From: Kate Little [REDACTED]
Sent: 05 October 2020 16:38
To: Simon Davis <Simon.Davis@arun.gov.uk>
Cc: Sam Pinkus [REDACTED]
Subject: RE: Yapton_yesterday's meet

Subject: Yapton_yesterday's meet

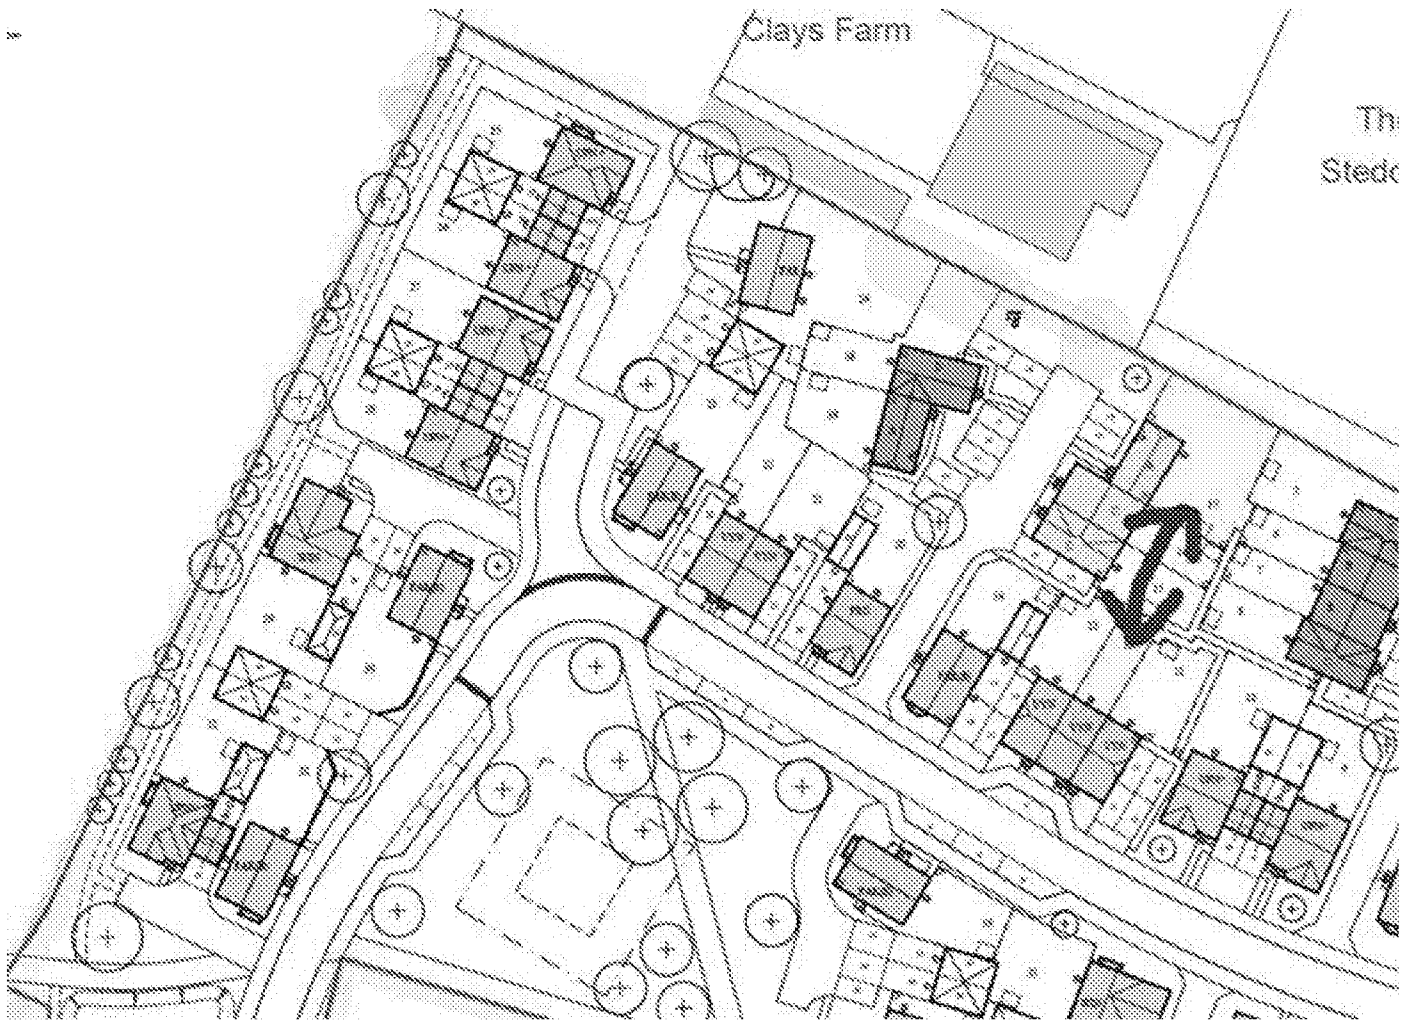
- Revisit proposed pedestrian access to Clay's Farm site providing hard surfaced footpath to our red line boundary, seek to make contact with the applicant's on adjacent site to align proposals.

- Amend boundary treatments to North End Rd – extend wall to rear of plots 3 & 4
- Provide landscape screening to plot 16s parking spaces to the front of plots 18/19

- Submit plans for sheds/ cycle storage
- Consider provision of grasscrete on parking spaces adjacent to POS
- North-south footpath to western boundary to be retained in public ownership

- Content for us to submit PRoW diversion application with amended route as shown
- Provision of a pond the preferred option though not mandatory. We'll explore options for retaining a smaller pond and enhancing with infiltration blanket or similar.

- Add boundary wall to gap in south-eastern corner, materials to match existing (as per Conservation Officer request)
- Decision can be delegated (obviously understood that it can't be guaranteed this position won't change).

- Revisit dispersal of AH plots on site.

- plot 12 to become AH and plot 17 private (38 unit scheme) and
- plots 5 & 6 to become AH and plots 32 & 34 private (70 unit scheme)?

Thanks for the Meeting Notes which I agree with. I also agree that the Affordable Housing layout changes are positive.
